# Conceptual Review Agenda

Schedule for 05/02/16 to 05/02/16

# 1506 W Horsetooth Rd Multi-family

## Village on Horsetooth – Conceptual Review (05/02/16)

**Village at Horsetooth**  
Fort Collins, Colorado  
OZ Architecture  
January 29, 2016

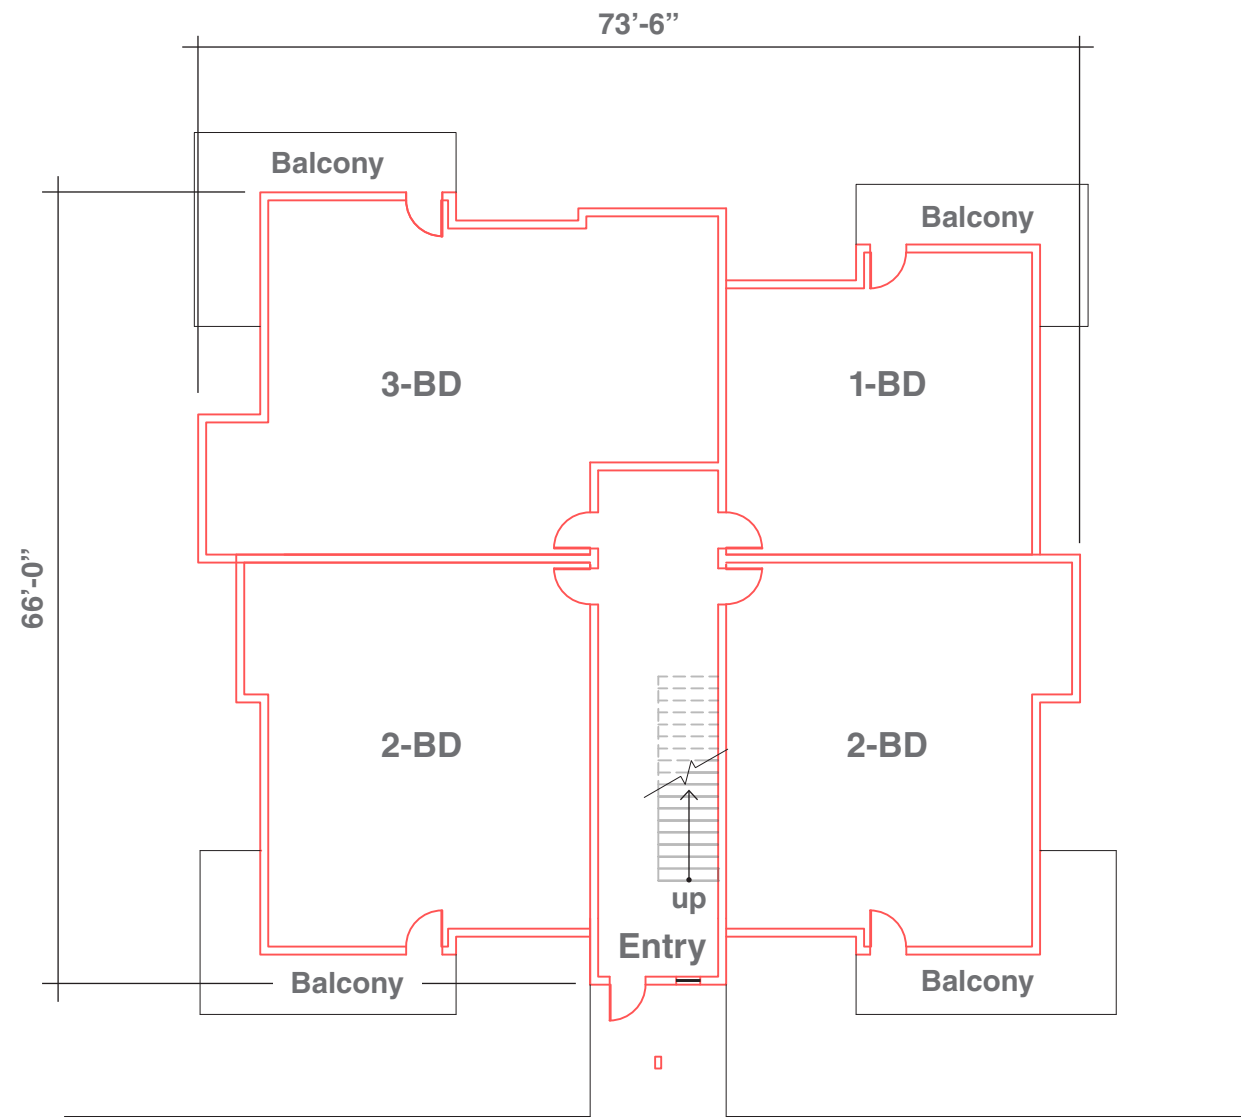
1. The plan as shown does not meet the connecting walkway standard in 3.5.2(D)(1) nor does the site plan provide the necessary connection to Birmingham Dr. The sidewalk network on the site is discontinuous and requires pedestrians to cross drive aisles with no delineation of pedestrian paths. The site plan also does not have buildings oriented to any sort of street, rather they are oriented around a parking lot with little connectivity to the sidewalk and road network in the surrounding area. The site plan will require fundamental changes to meet these code requirements. Staff would be happy to meet and discuss these changes in further detail.

2. While the project narrative contains the number of bicycle parking spaces to be provided as part of this development, the site plan does not show the location of these bicycle parking spaces. Please provide more detail on where bicycle parking will be provided on-site. If the enclosed spaces will be provided in the unit, please submit a floor plan of each unit type showing where the bicycle parking will be provided.

3. What is the square footage of each building? The maximum floor area allowed per building in the LMN is 14,000 sq. ft. If any of the buildings exceed the maximum floor area, you will be required to submit a modification request to this standard.

4. The maximum number of units allowed per building in the LMN is 12. Three of the buildings exceed the maximum number of units. Please submit a modification request to this standard.

8. It is unclear how this plan meets the parking lot perimeter landscaping. Parking areas abutting streets and adjacent uses must be screened to screen at least 75% of the shine from headlights. The parking areas also must have one tree per 25 lineal feet.

# A1

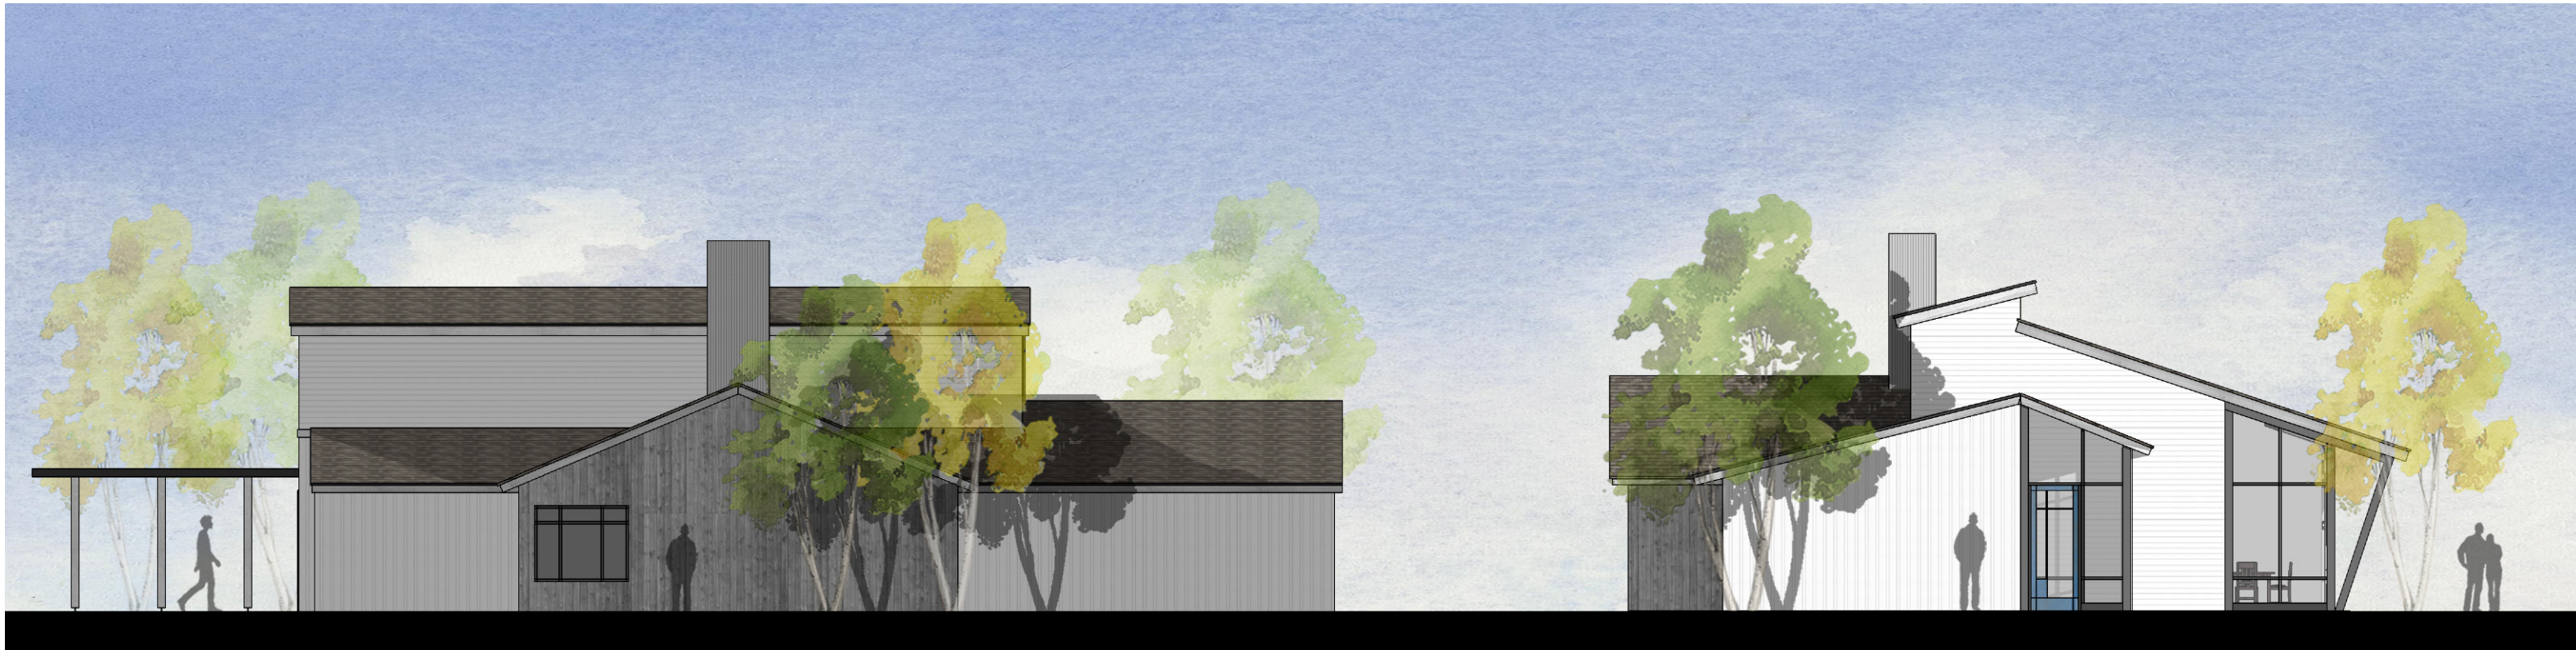
5. The submittal does not include proposed elevations for the A2 building. Include the proposed elevations for A2 as part of your PDP submittal.
6. Will the elevations for all of the 8-unit buildings be the same? Since there are more than 7 buildings proposed as part of this plan, there will need to be 3 distinctly different building designs. It is unclear if this proposal meets that standard at the moment.

CONCEPT SITE PLAN  
2629 W. HARMONY ROAD  
JOB NO. 3473300  
APRIL 21, 2016  
SHEET 1 OF 1

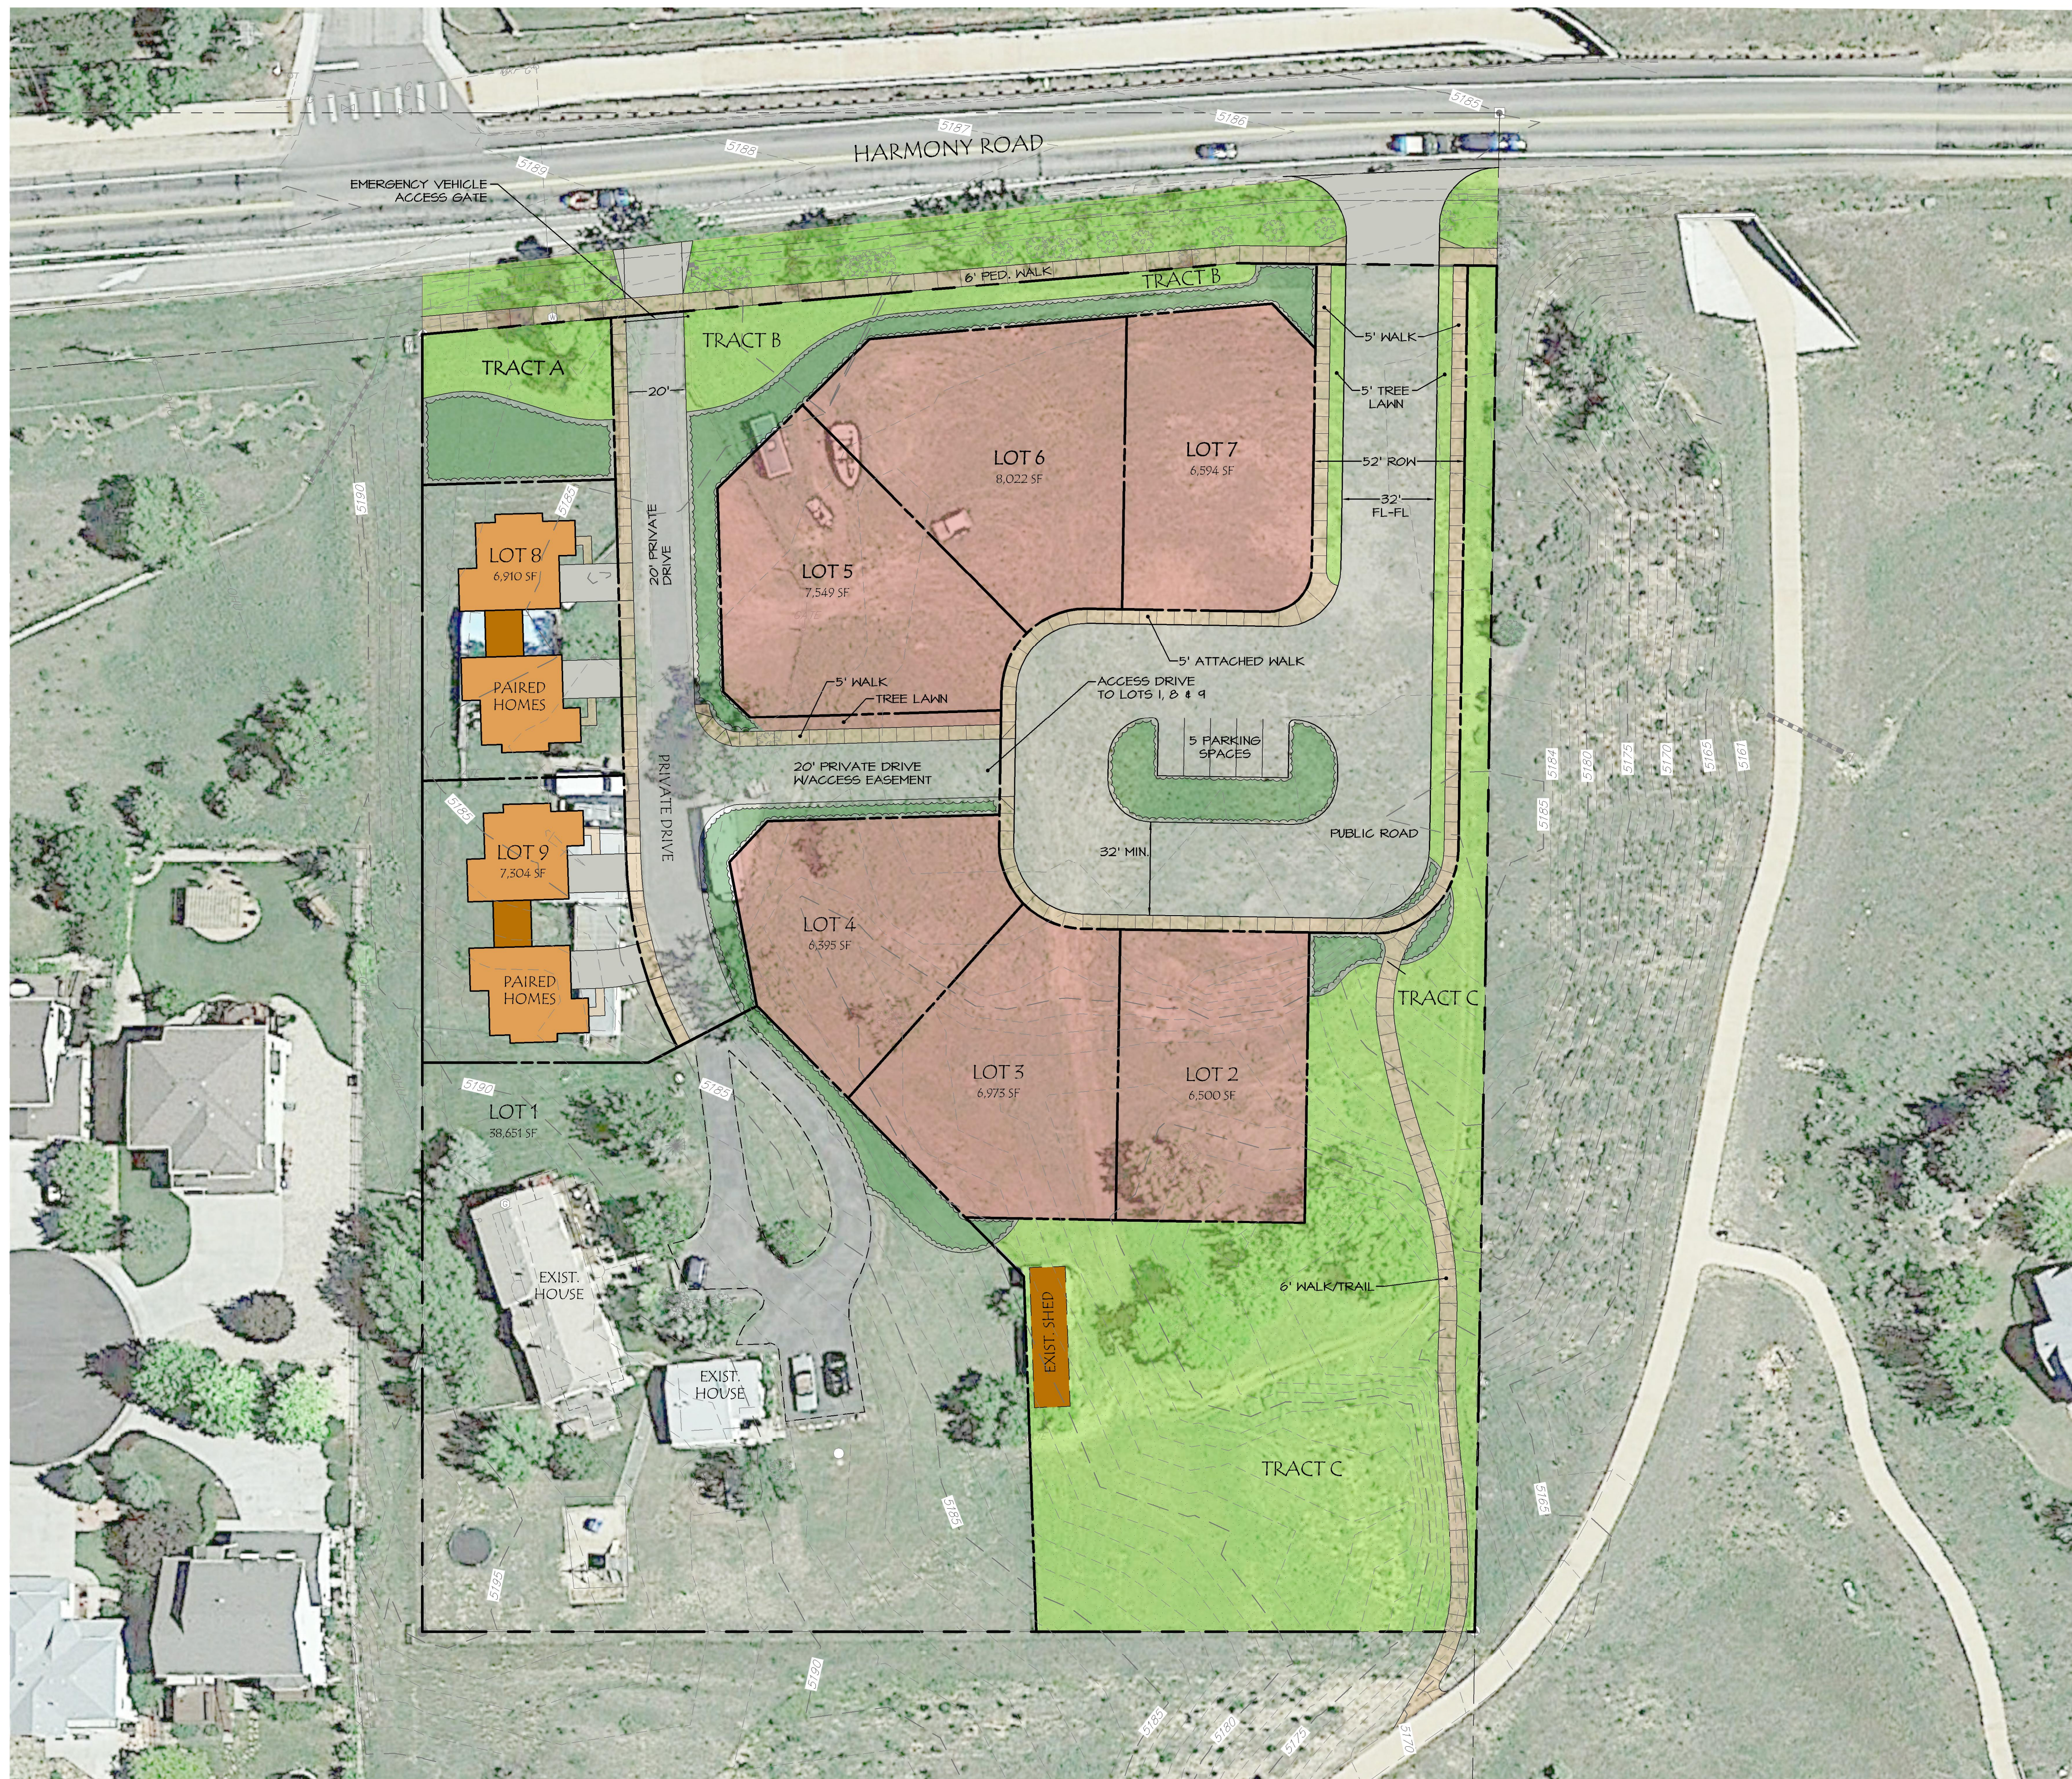
1. The anticipated change in traffic volume is not expected to rise to the threshold of needing a TIS. Based on section 4.2.3.D of LCUASS, the Traffic Impact Study requirement can be waived. Although the study can be waived, note that there may be traffic related details that will need to be determined during the process.
2. It would be best if the access could align with the roadway across CR 38E. If not, we'll need to maximize the access spacing.
3. Since CR 38E is an arterial, a full movement access will require a left turn lane.
4. Frontage improvements along CR 38E will be needed, and the trail connection is very nice.
5. Overall internal street layout seems awkward and not very intuitive.
